*Tradition Design Review Committee
Architectural Review*

Date: 5.2.25

*Regarding: Southern Grove SG-3 Commercial (NW Corner) – **Preliminary** Site Plan, Landscape Plans and Elevations*

STATUS: Conditionally Approved

© WEST ELEVATION - reference only
1/8" = 1'-0"

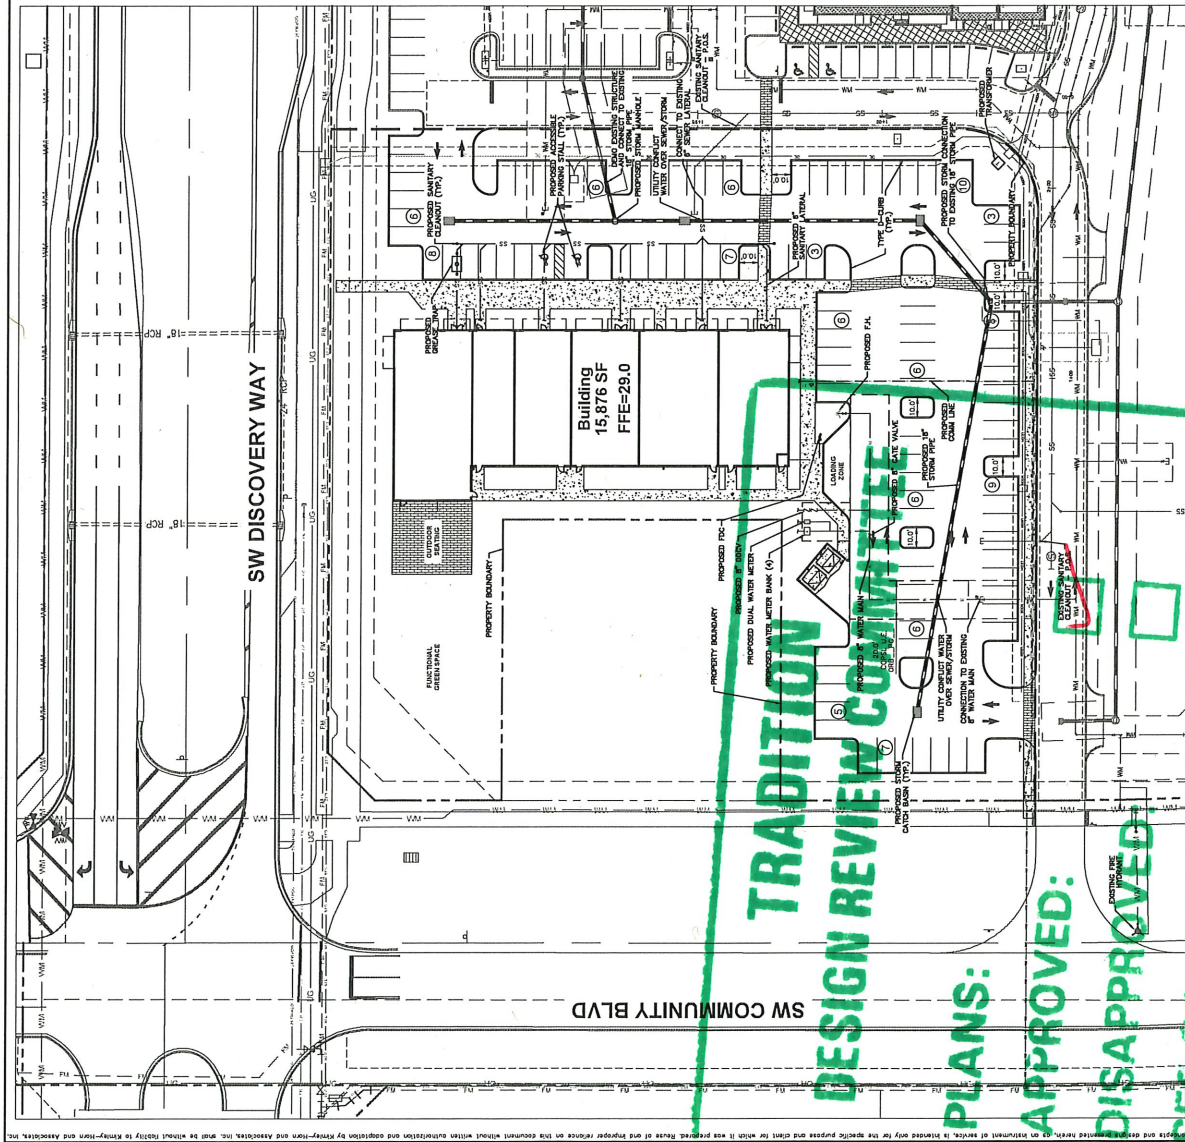
- *Site Plan – Conditionally approved – NOTE: committee has concerns that Loading Zone is sufficient for operation.*
- *Elevations, Colors & Materials - Conditionally approved – committee recommends applicant consider wrapping parapet/molding around the corner given this NW corner of the building faces toward Discovery Way/Community Blvd intersection (see below)*
